US Route 2, Rural Major Collector, Bridge 32
Town of Richmond, Project BF 0284(28)

25'-0" x 5'-3" Rigid Frame Bridge
Pile Cap Details

DWG NO.
S3.2

2 S3.2 BF1 ELEVATION VIEW
⅜" = 1'-0"

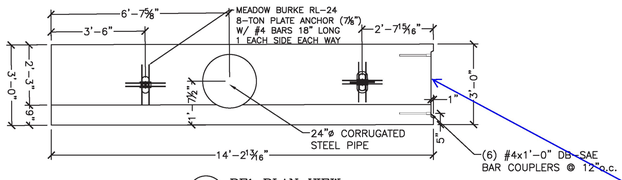
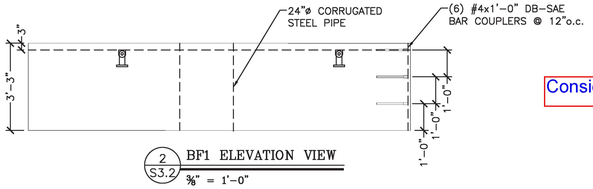
Consider adding roughened surface to these closure pour faces to increase bond and overall stiffness of footing.

I am wondering how the contractor will assemble the footing and slide it down over the piles. Do they first insert all the rebar into the couplers and then slide the entire footing down onto the piles? If so that seems like a difficult thing to rig and lift without the pieces moving. I don't see how, if they first slide each footing piece down over the pile, they can then insert a 3' long rebar into a 1' wide space to get the bar ends into the couplers. Seems like we usually utilize protruding bar from the adjacent pieces for closure pours like this.

Considered for the future.

Place the abutment pieces; insert the L-bars, which are 12" x 8" = 20"; place the FB2 stirrups; place the FB3 straight bars.

15 S3.2 CLOSURE POUR DETAIL
⅜" = 1'-0" PLAN VIEW

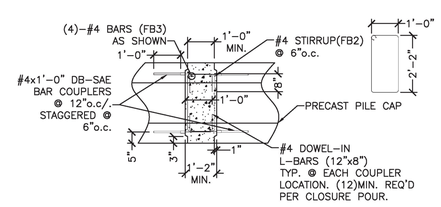
Show elevation view
